**NATIONAL RAILROAD PASSENGER CORPORATION
NORTHEAST CORRIDOR
NEW YORK - WASHINGTON
SUMMARY BULLETIN ORDER No. NYW1-25SUM
Effective 12:01 AM, Monday, February 2, 2026**

INDEX OF RULE / SI CHANGES OR MODIFICATIONS CONTAINED IN THIS BULLETIN ORDER

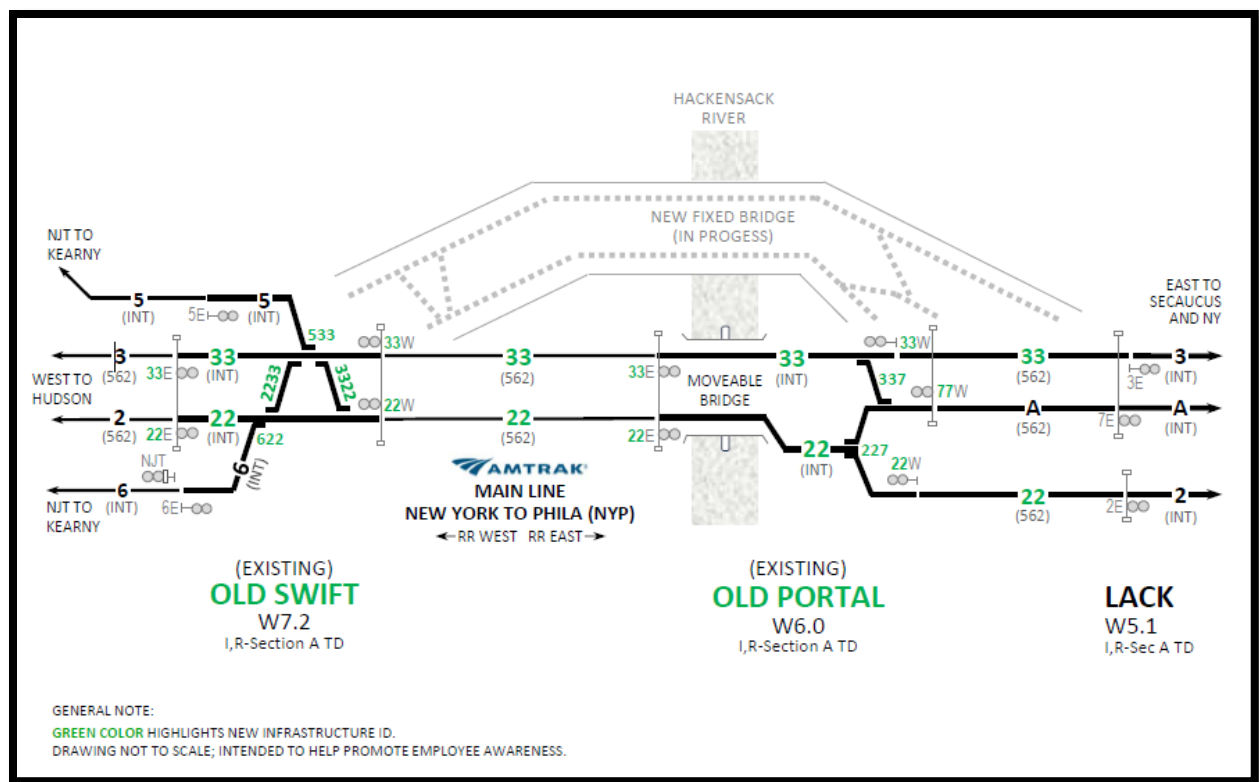
5. Old Swift Switch Designation Changes

- No. 23 Switch at Old Swift is now designated as the No. 2233 Switch.
- No. 32 Switch at Old Swift is now designated as the No. 3322 Switch.
- No. 53 Switch at Old Swift is now designated as the No. 533 Switch.
- No. 62 Switch at Old Swift is now designated as the No. 622 Switch.

K. 277-N3. Non-Conforming Aspect: Old Portal to Old Swift

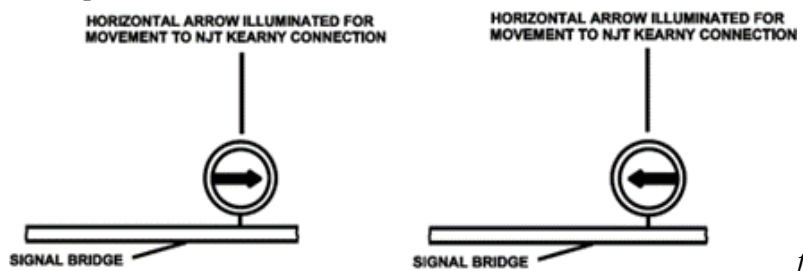
277-N3 is retitled. No. 2 & 3 Trks are modified to No. 22 & 33 Trks.
